RECEIPT DATE: 7/19/16 **ONSITE SEWAGE DISPOSAL SYSTEM** P 558800

PROPERTY ADDRESS: 11807 Chapel Estates Drive

BAT SITE PLAN
CHAPEL RISE, LOT 1
 1107 CHAPEL ESTATES DRIVE
 ZONED RC-DEO PLAT NO. 22022
 TAX MAP NO.: 29 GRID NO'S: 0 & 14
 5TH ELECTION DISTRICT HOWARD COUNTY, MARYLAND
 SCALE: 1" = 30' DATE: JANUARY 2016
 SHEET 2 OF 2

BAT SITE PLAN
CHAPEL RISE, LOT 1
 11807 CHAPEL ESTATES DRIVE
 ZONED RC-DEO PLAT NO. 22022
 TAX MAP NO.: 29 GRID NO.S: 8 & 14
 5TH ELECTION DISTRICT HOWARD COUNTY, MARYLAND
 SCALE: 1" = 30' DATE: JANUARY 2016
 SHEET 1 OF 2

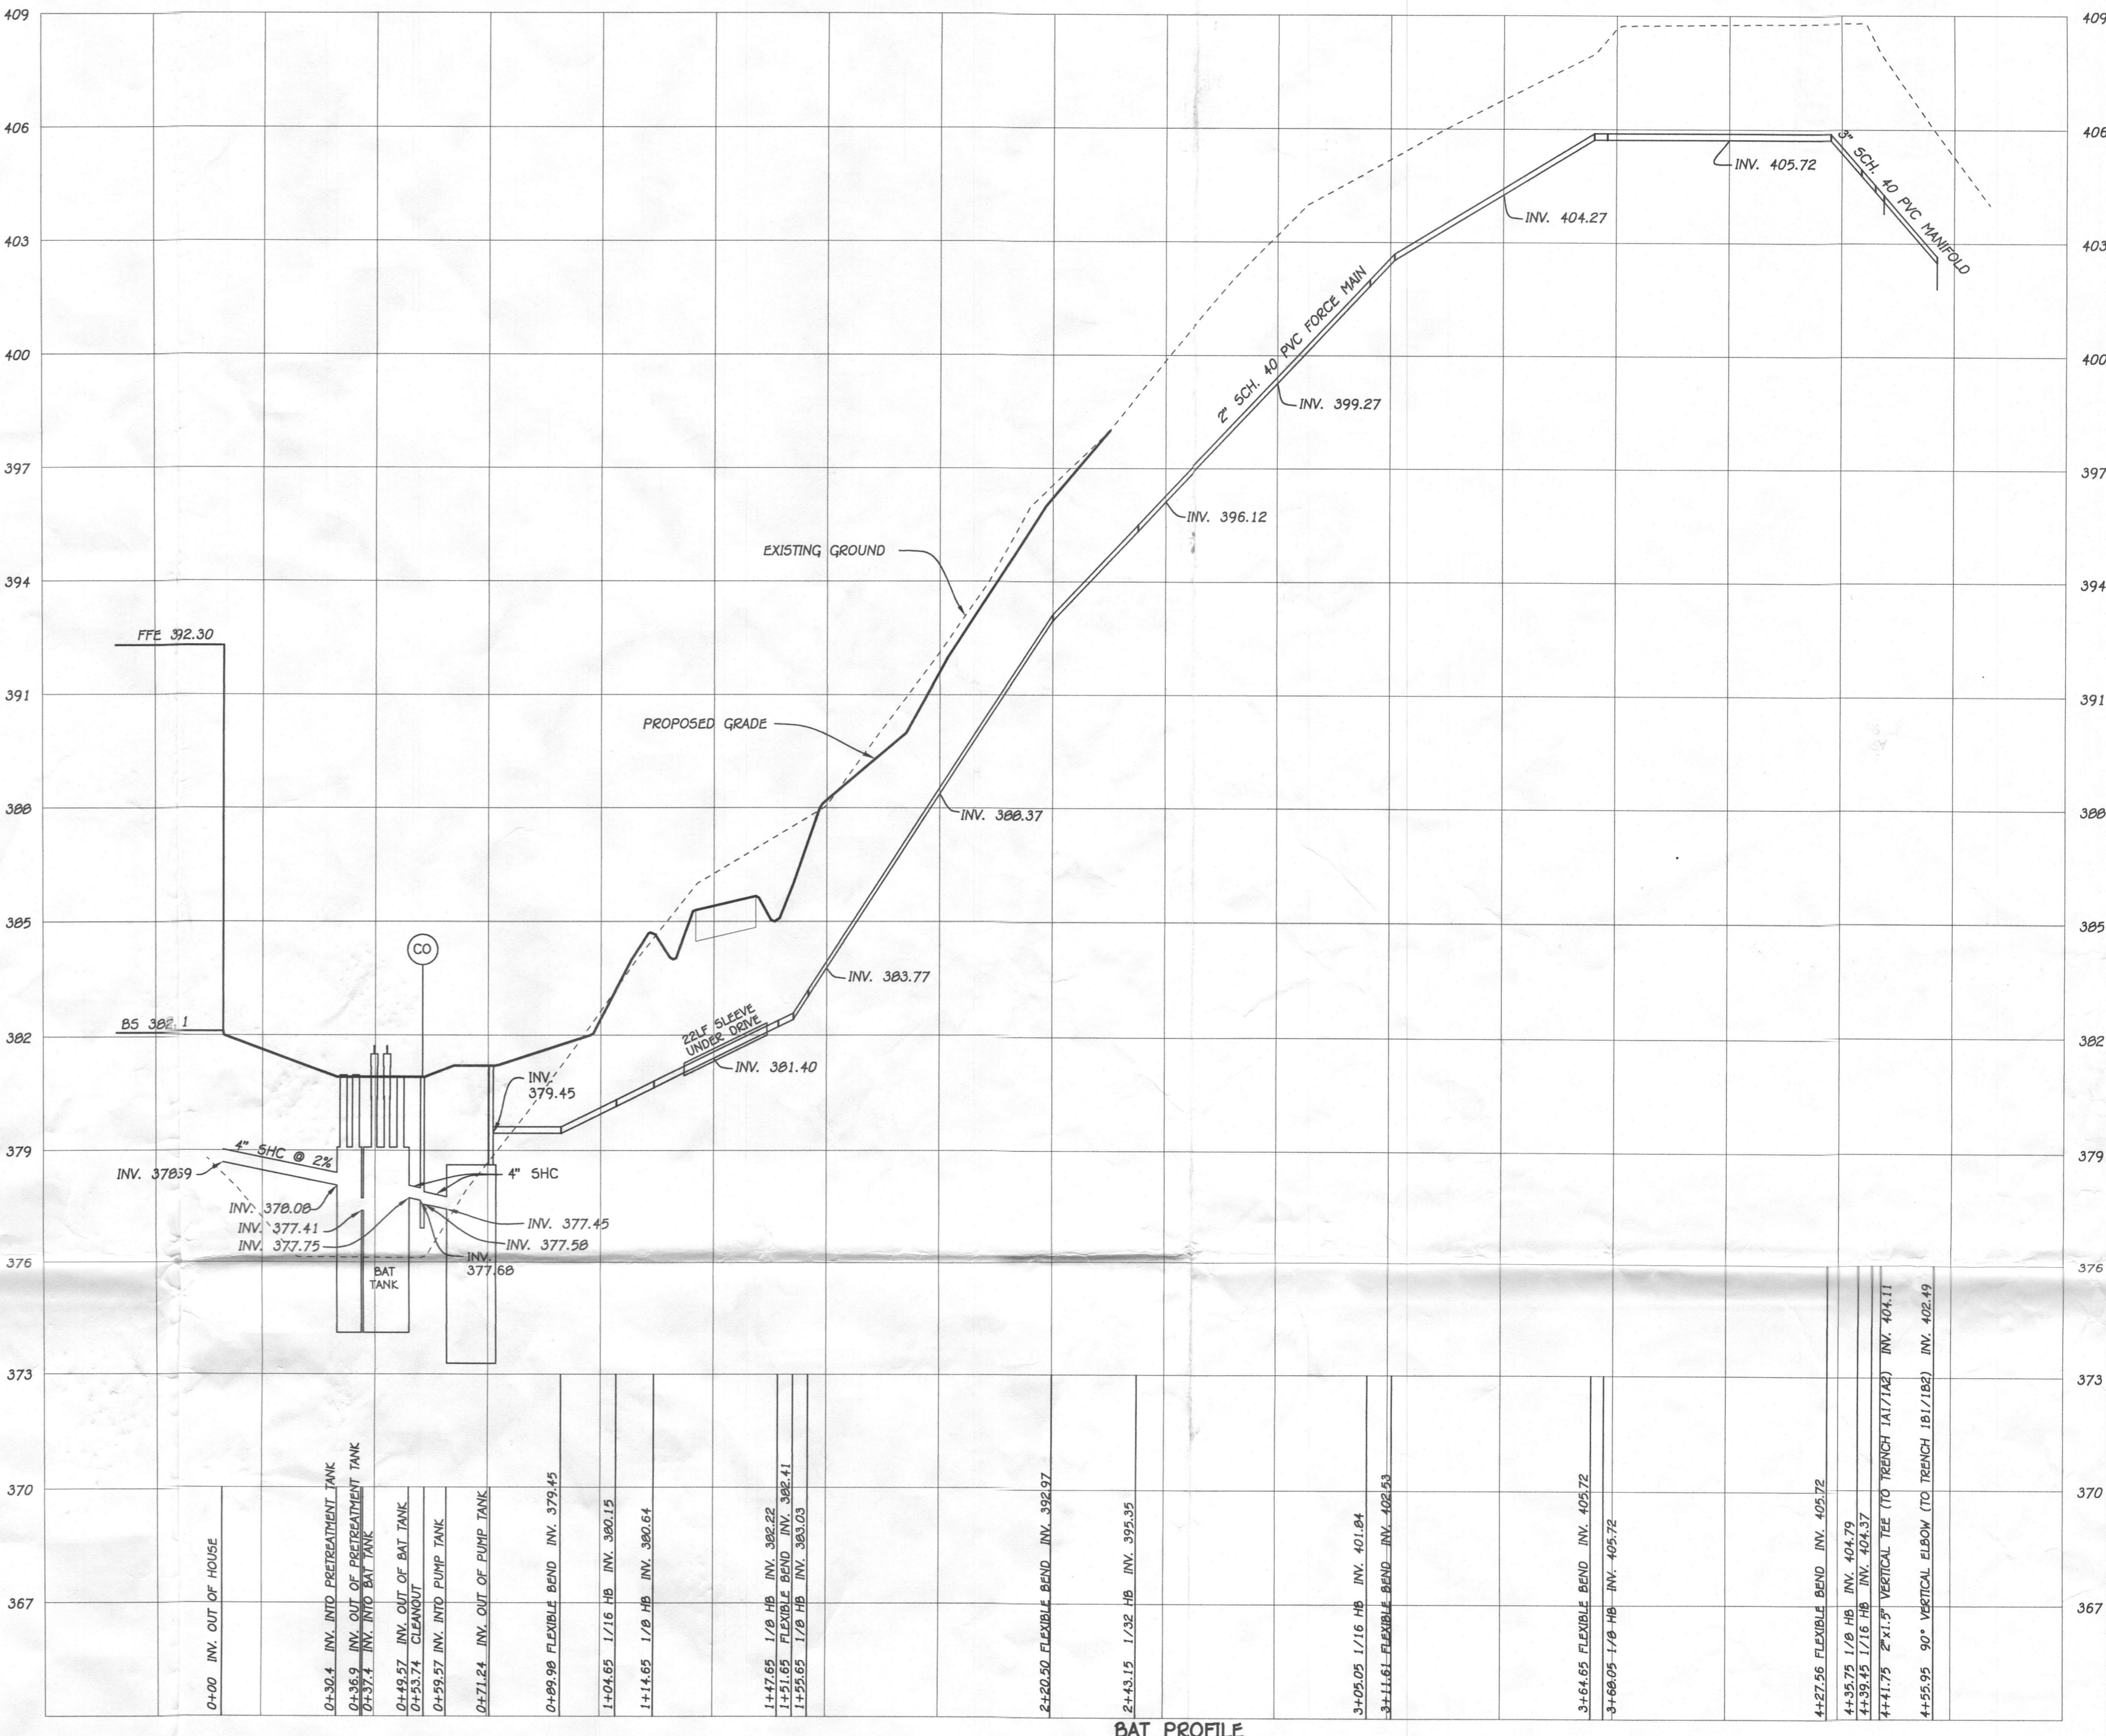
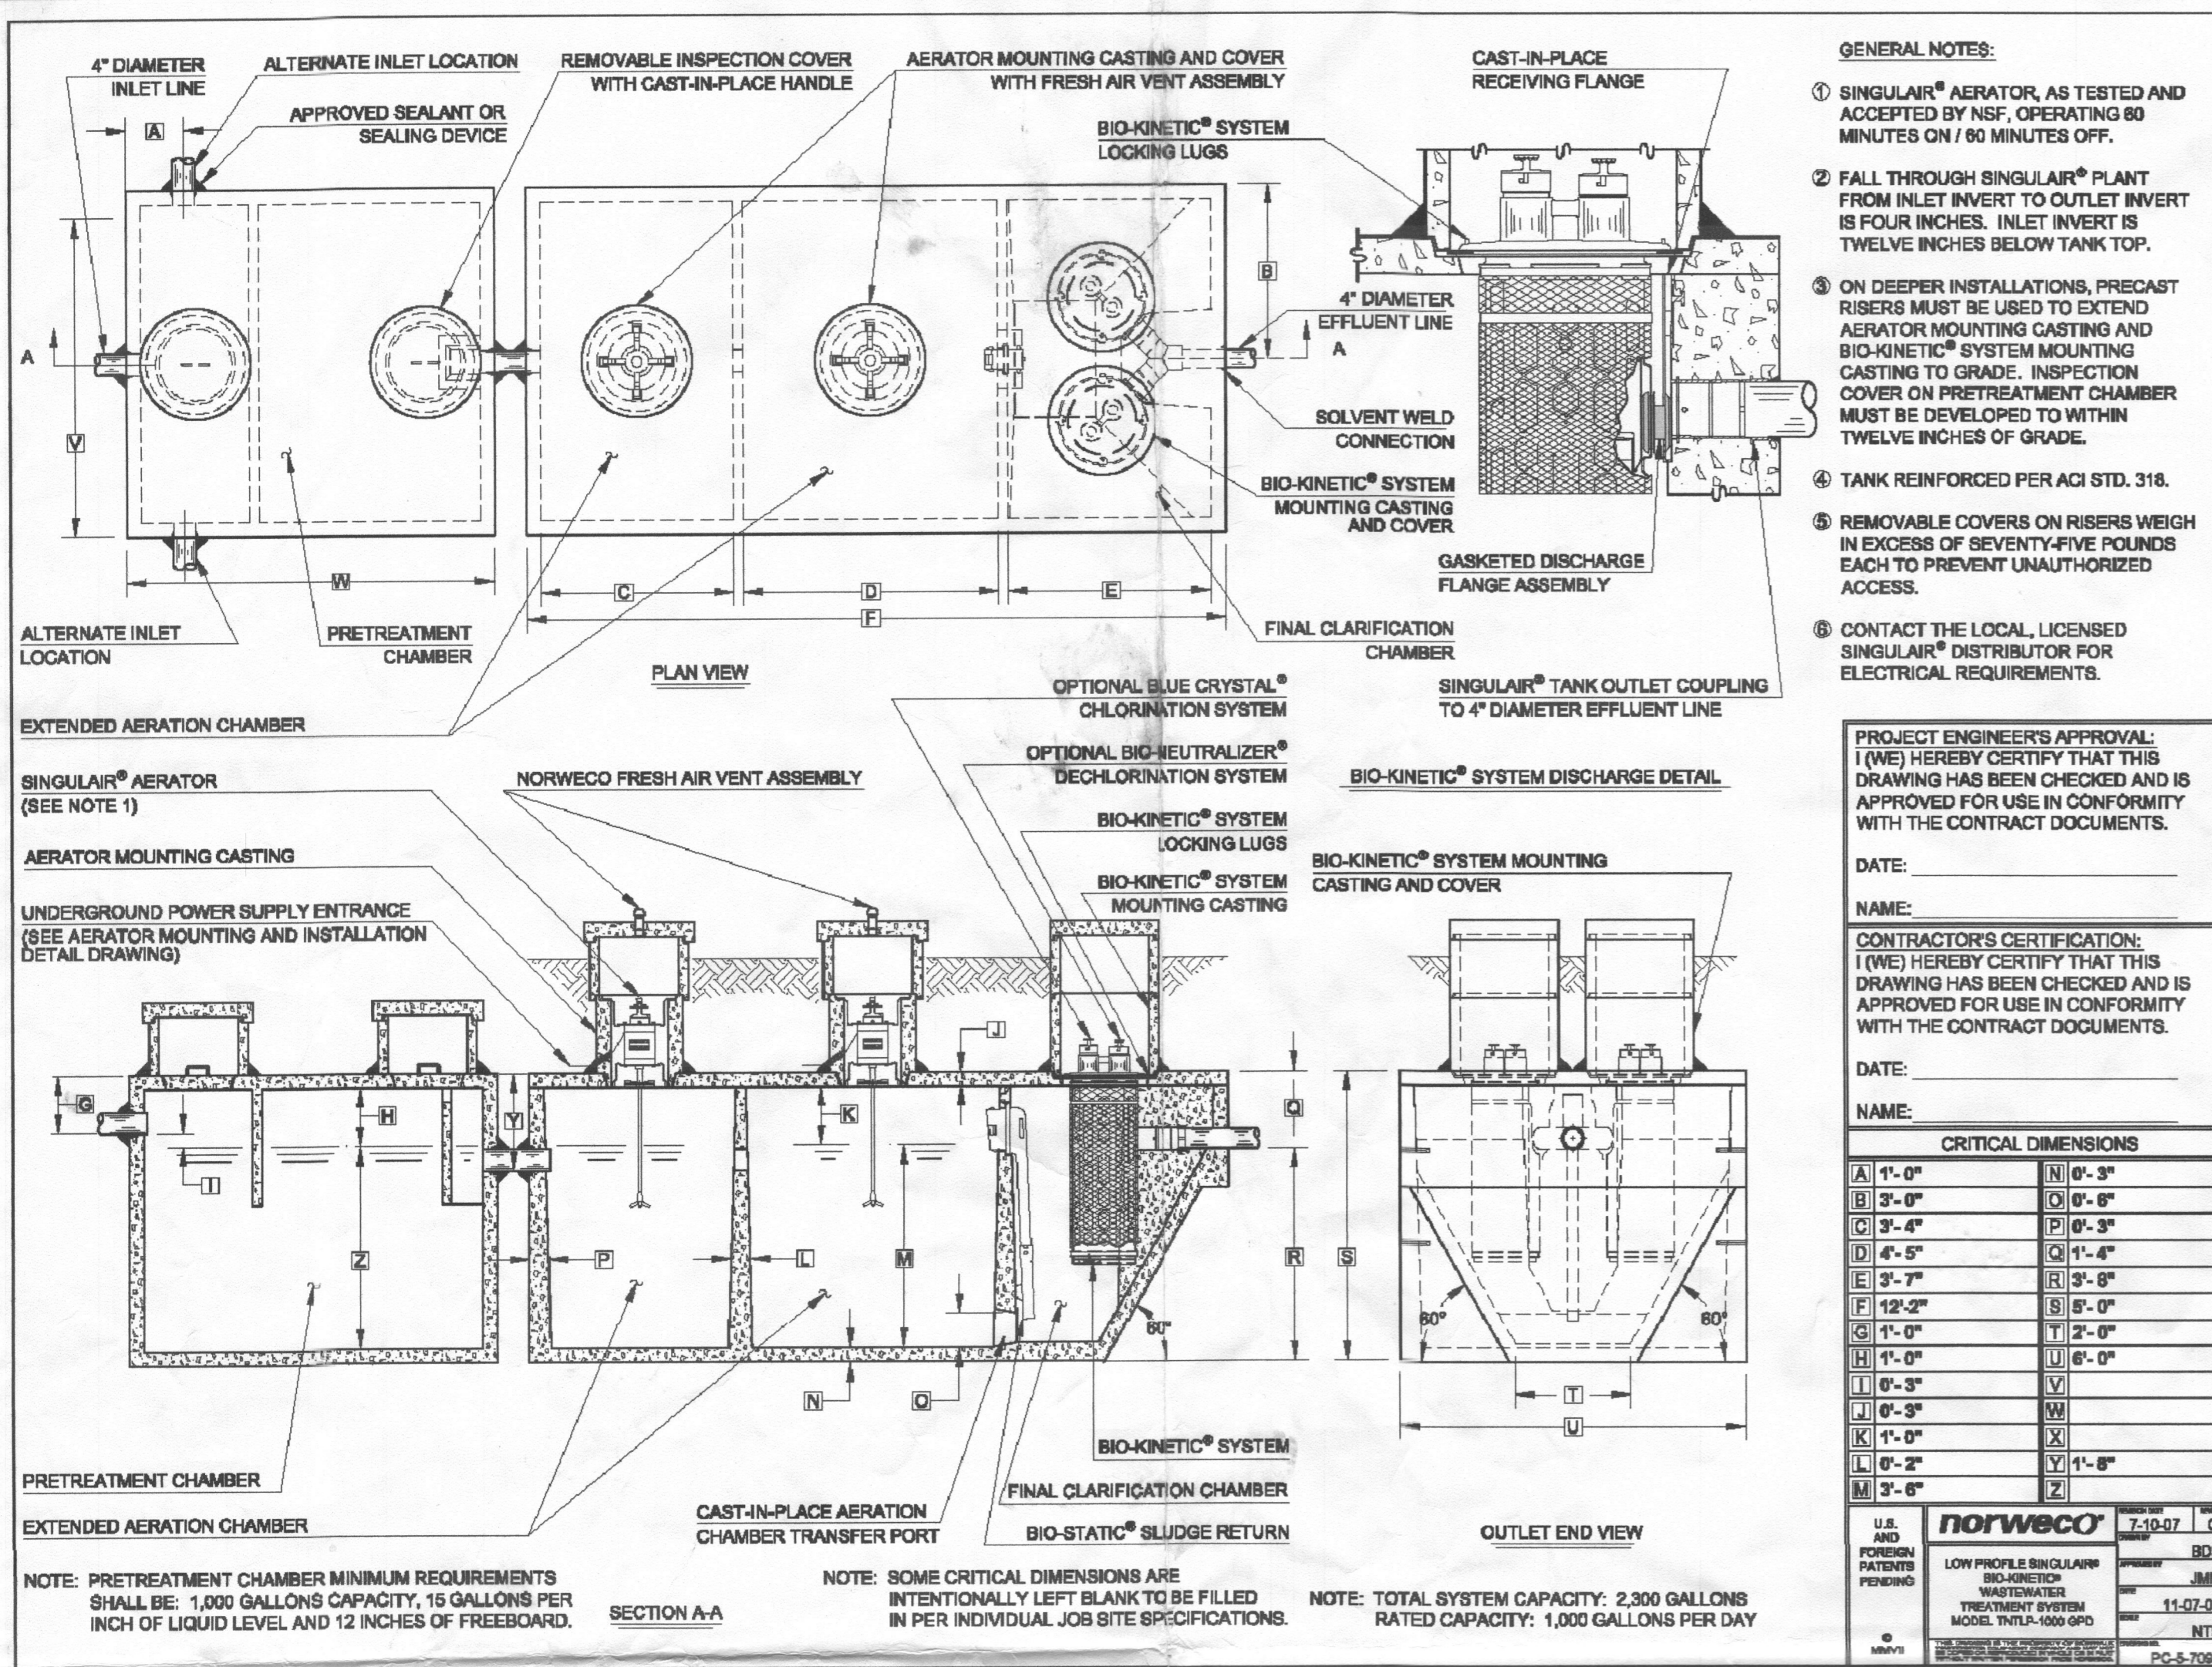
As we discussed in the meeting you cannot use monarch tanks and it has to be changed on the most recent plan you sent in. Everything else looks good. Please revise showing the new tank as we discussed.
